## **SERVICE BULLETIN**

SERVICE BULLETIN M20-281

SUBJECT: Alternate Air Duct - Inspection for confirmation of configuration and subsequent replacement

MODELS/ S/N AFFECTED: M20M - S/N 27-0290 THRU 27-0316; and any S/N's, which may have had a Seamech

## FIGURE SB M20-281-1

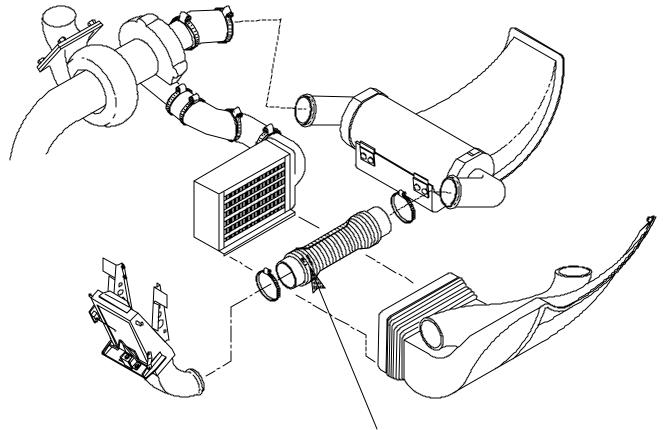
INTRODUCTION: On one aircraft, the coiled wire inside the Alternate Air (rubber) Duct , P/N 0906913

(Seamech) has come loose at the end of the coil and is unwinding within the duct, inside wall. The vendor, Seamech, has re-designed the duct and re-identified it as P/N 0906913

The Seamech, original configuration, P/N 0906913, Alternate Air Duct must be replaced with the new P/N 0906913 (Revision A) configuration within the time frame stated above. If a Baxter Woodhouse & Taylor, P/N X6913, Alternate Air Duct is installed and has not deteriorated beyond visual serviceability criteria, it is an acceptable configuration and does

- 1. Remove top and bottom cowling from aircraft.
- Inspect the installed Alternate Air Duct for configuration identification. If the Seamech duct does not have (Rev. A) stamped/written adjacent to the P/N, the duct must be replaced.
- 3. Loosen hose clamps at both ends of the Alternate Air Duct, and remove the duct from the aircraft.
- 4. Replace with either a Baxter Woodhouse & Taylor, P/N X6913, or the Seamech, P/N 0906913 (Rev. A).
- 5. Install Duct and secure hose clamps at both ends.
- 6. Inspect entire engine compartment for obvious (visual) conditions of deteriorated or malfunctioning components.
- 7. Re-install bottom and top cowling onto aircraft.
- 8. Enter appropriate Log Book records to show compliance with SB-M20-281.
- 9. Return aircraft to service.

SEAMEGH P/N (& Rev. A) MARKED ON DUGT AT RANDOM LOCATIONS
